**HILLSIDE AT LORSON RANCH**

**EARLY OVERLOT GRADING / EROSION CONTROL PLANS**

Engineering Review  
03/30/2022 8:50:30 AM  
dsdrice  
JeffRice@elpasoco.com  
(719) 520-7877  
EPC Planning & Community  
Development Department

**COVER SHEET  
EARLY GRADING AND  
EROSION CONTROL PLAN**

**HILLSIDE AT LORSON RANCH  
 OVERLOT EARLY GRADING AND  
 EROSION CONTROL PLAN**

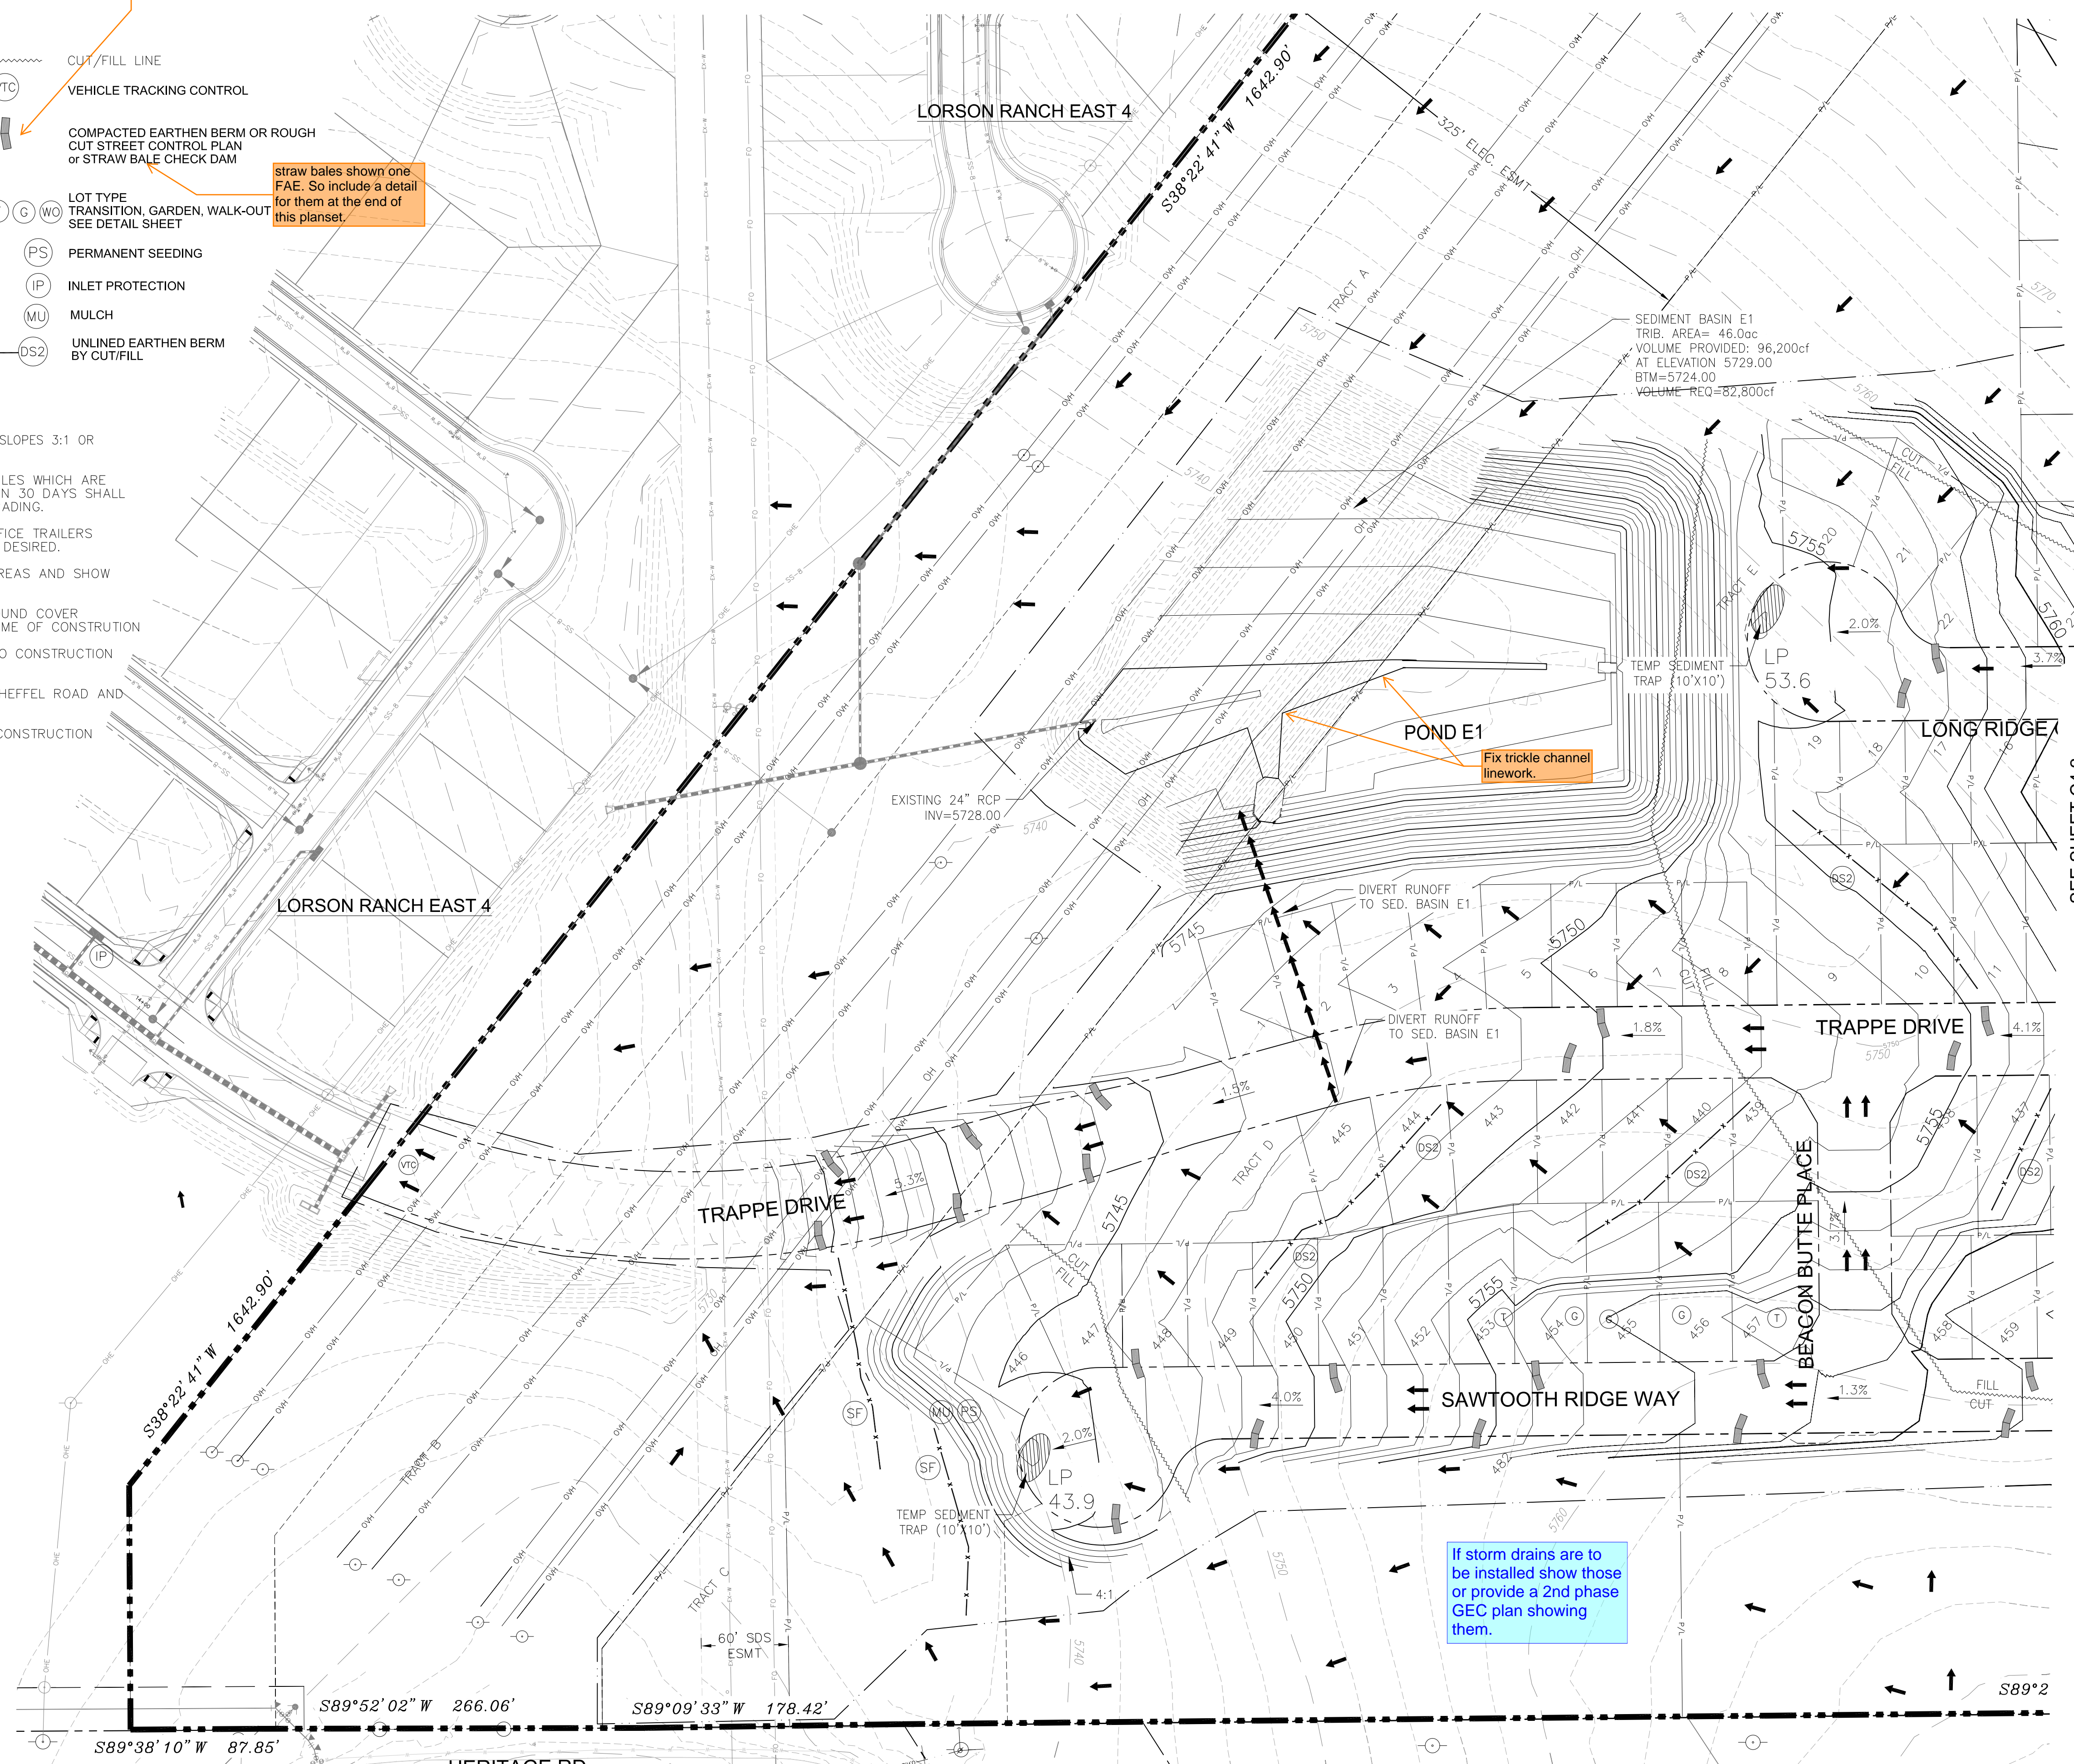
600LF of straw wattles also shown on FAE. Add them to this symbol description, or give them their own line in the Legend, and show locations on plans.

straw bales shown one FAE. So include a detail for them at the end of this planset.

Include CWA's in this note or add it to the Plans and Legend. 2 are shown on the FAE.

SWMP states 65%. Revise to remove discrepancy.

**HILLSIDE AT LORSON RANCH  
 OVERLOT EARLY GRADING AND  
 EROSION CONTROL PLAN**

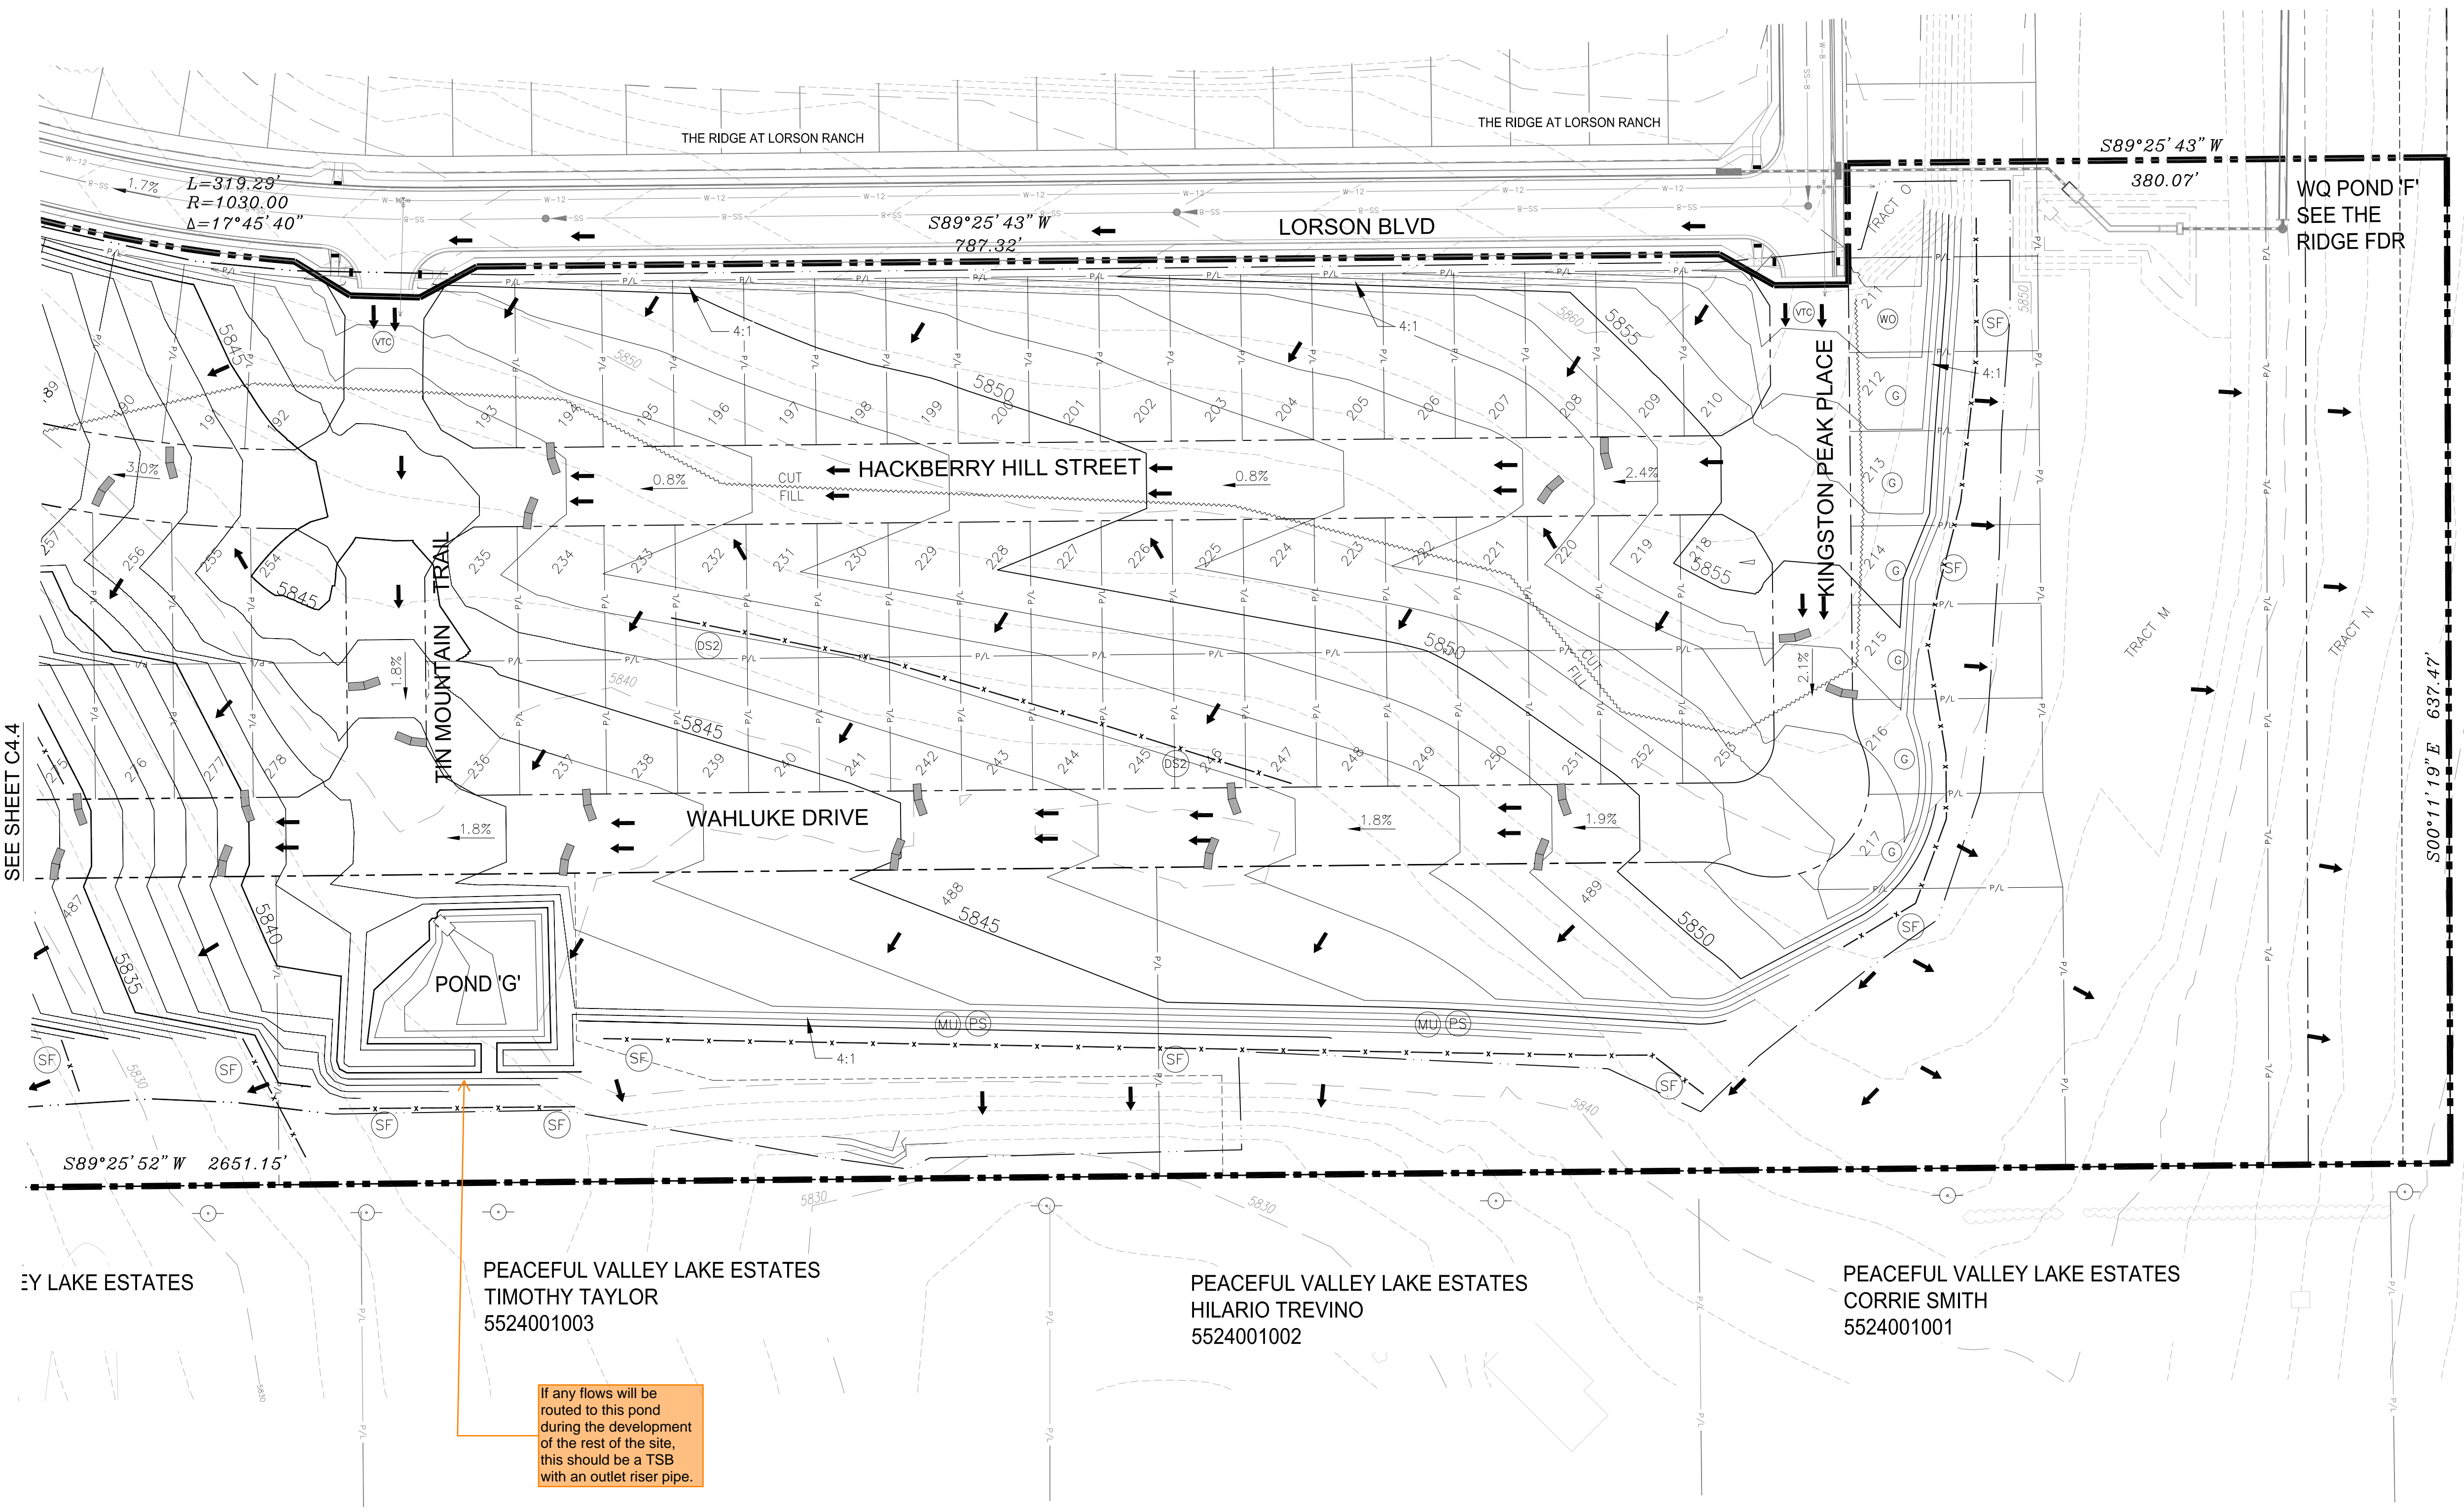
Please add legend to sheets where it will fit.

**POND E1**  
**POND GRADING AND**  
**TRICKLE CHANNEL**

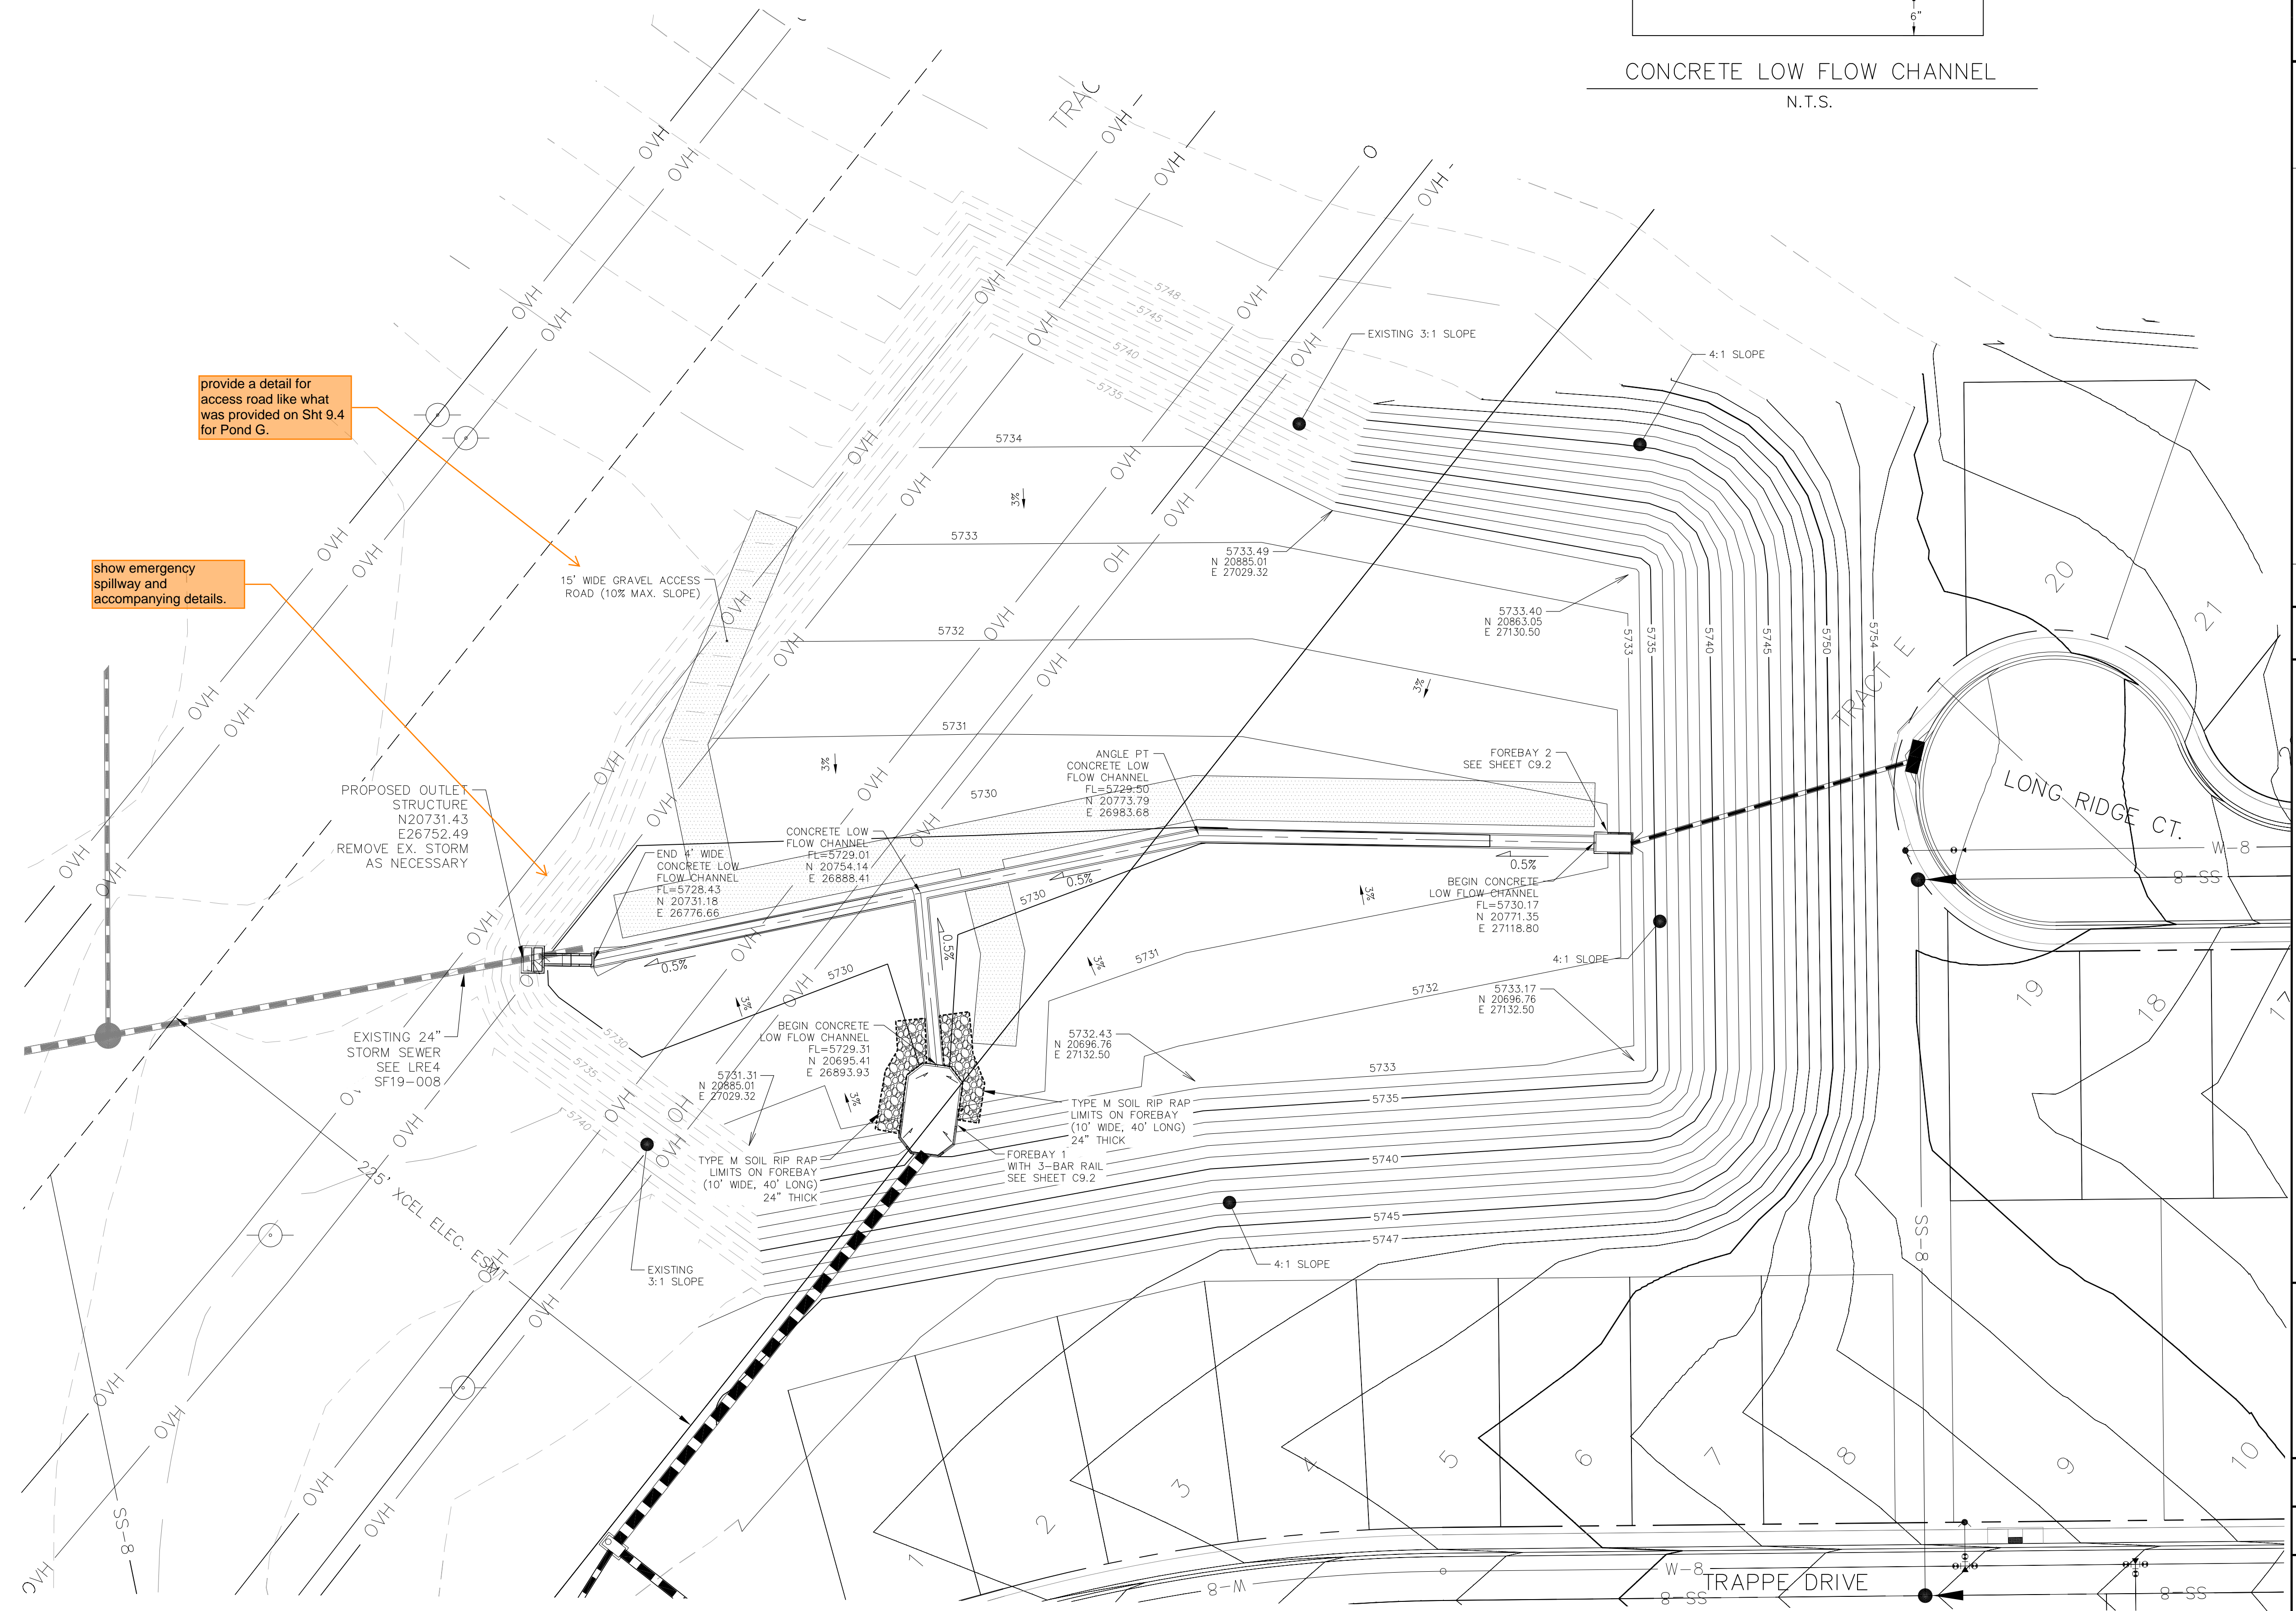
provide a detail for access road like what was provided on Sht 9.4 for Pond G.

show emergency spillway and accompanying details.
